Project	IEEE 802.16 Broadband Wireless Access Working Group < http://ieee802.org/16 >	
Title	Problems with Initial Ranging in OFDM PHY and a Solution	
Date Submitted	2005-01-26	
Source(s)	David A Castelow, Gavin Meakes, Eyal Verbin Airspan Communications, Cambridge House, Oxford Road, Uxbridge, UK Joël Demarty, Ambroise Popper SEQUANS Communications 101-103 bld Mc Donald, 75019 Paris, France	Voice: +44 1895 467281 Fax: +44 1895 467202 mailto:dcastelow@airspan.com Voice: +33 1 44 89 48 07 mailto:joel@sequans.com
Re:	Supporting document for Comment to 802.16maint.	
Abstract	Changes required in order enabling good operation of 802.16 systems.	
Purpose	The document is intended for consideration within the comments resolution process.	
Notice	This document has been prepared to assist IEEE 802.16. It is offered as a basis for discussion and is not binding on the contributing individual(s) or organization(s). The material in this document is subject to change in form and content after further study. The contributor(s) reserve(s) the right to add, amend or withdraw material contained herein.

Problems with Initial Ranging in OFDM PHY and a Solution

*David A Castelow, Gavin Meakes, Eyal Ve

Figure 60 – Initial Ranging – SS (part 1)

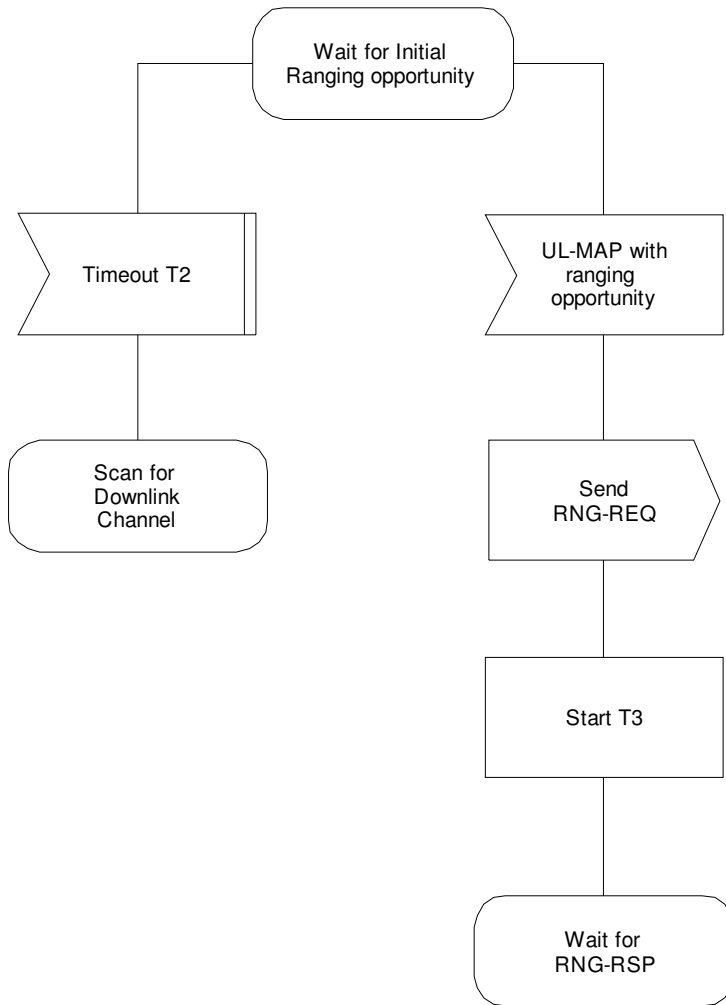
Page 182, Line 34

Test "Time to increase power?" does not seem to have a timer associated with it. It is in conflict with the text at [2, page 178, line 53 and page 179, line 6]. In these lines the power is required to be increased at each step. However, the change in power is not defined in the standard, and so the power step could be zero or changed dynamically. We suggest replacing the power step with an instruction to adjust the power.

[Replace Figure 61 with the following figure:]

Figure 85 – CDMA Initial Ranging – SS (part 1)

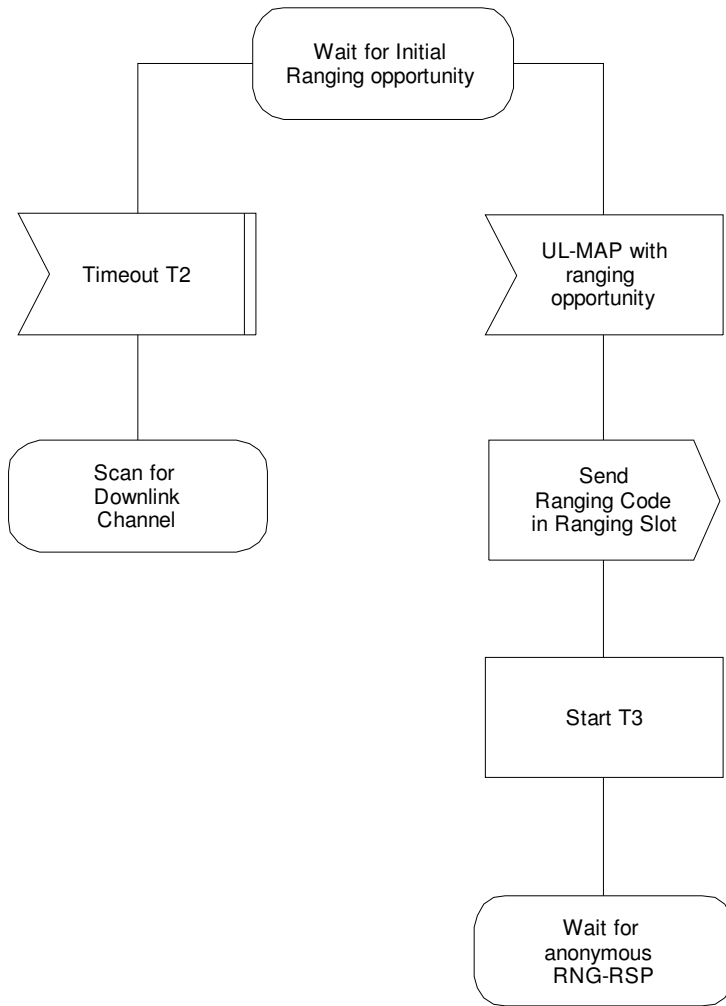
NOTE 1 — Timeout T3 may occur because the CDMA codes or the RNG-REQ from multiple SSs collided. To avoid these modems repeating the loop in lockstep, a random backoff is required. This is a backoff over the ranging window specified in the UCD. T3 timeouts can also occur during multi-channel operation.

NOTE 2 — On a system with multiple uplink channels, the SS must attempt initial ranging on every suitable uplink channel before making the downlink channel unusable and moving to the next available downlink channel.

Figure 210a – Subchannelized Initial Ranging – SS (part 1a)

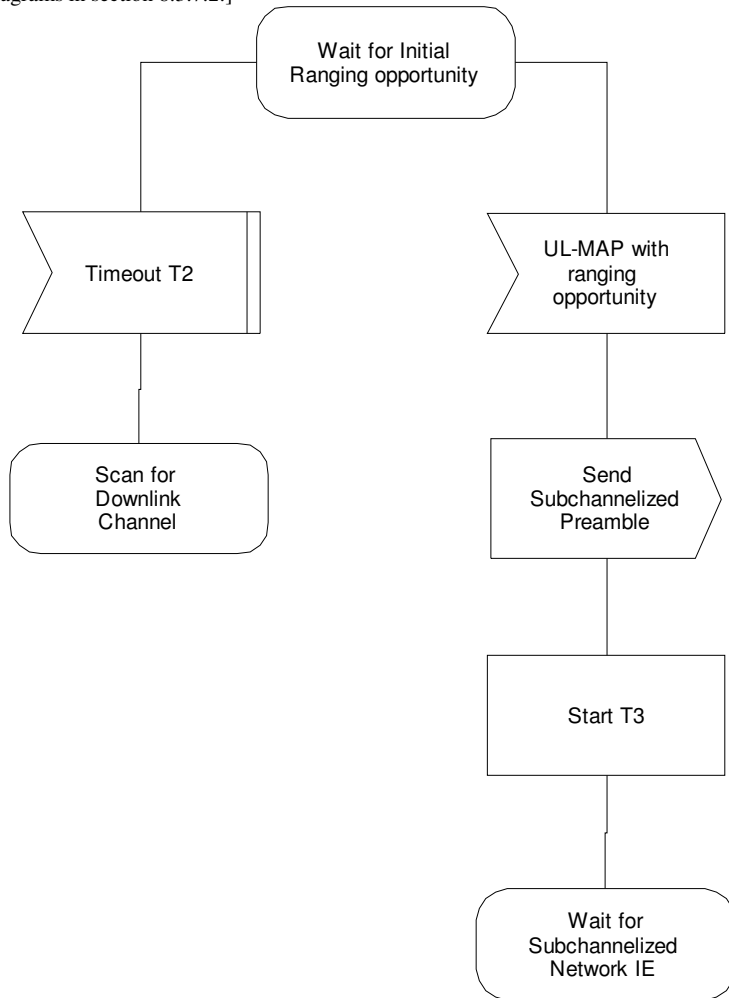
~~SSs that compute their $P_{TX_IR_max}$ to exceed their maximum power level and SSs which have attempted initial ranging with the maximum power level using RNG-REQ may, if the BS supports subchannelization, attempt initial ranging in an initial ranging slot using the following burst format, as indicated in Figure 210a and Figure 210b:~~

[Include the following diagrams in section 8.3.7.2:]
